Drawing Title:  
**Proposed West Elevation**

Project: **Old Quay Ope, Penryn**  
 Client: **Glasney College Ltd**

ISSUE FOR PLANNING MINOR AMMENDMENT AND ASSOCIATED LISTED BUILDING CONSENT 23.02.24

J-24-04-OLD  
 Drawing No. Revision:  
**P06 -**

**Proposed West Elevation 1:100 @ A3**

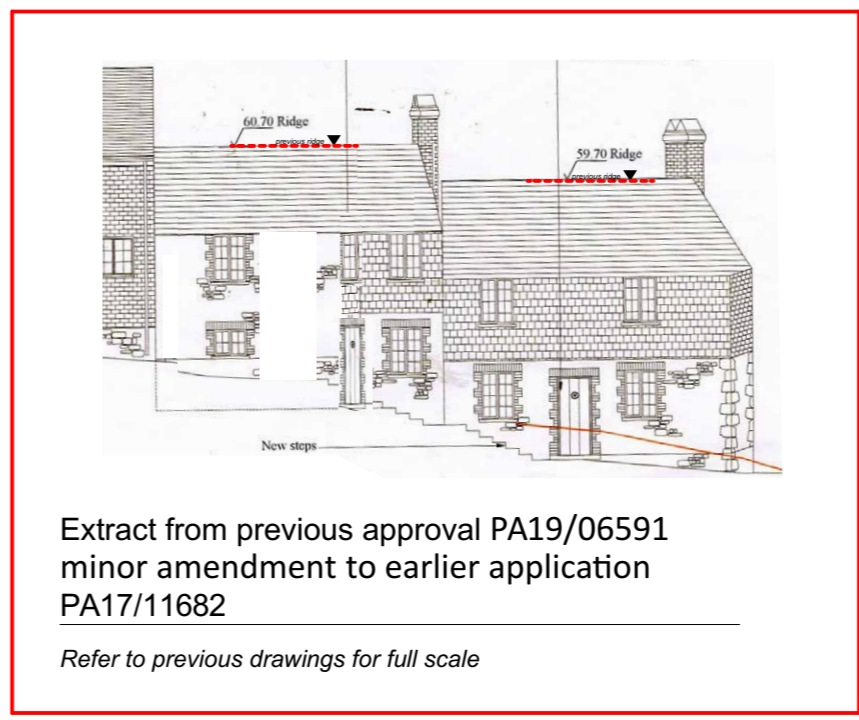
**No 3 Old Quay Ope**  
 - hip against no. 2 added to improve amenity to no. 2 balcony  
 - false chimney omitted  
 - cat slide lead dormers added to match existing on no. 2 and to help with head height due to alterations in floor levels resulting from site construction changes

**No 4 Old Quay Ope**  
 - false chimney omitted  
 - cat slide lead dormers added  
 - curved corner detail added  
 - brick lintels replaced with timber
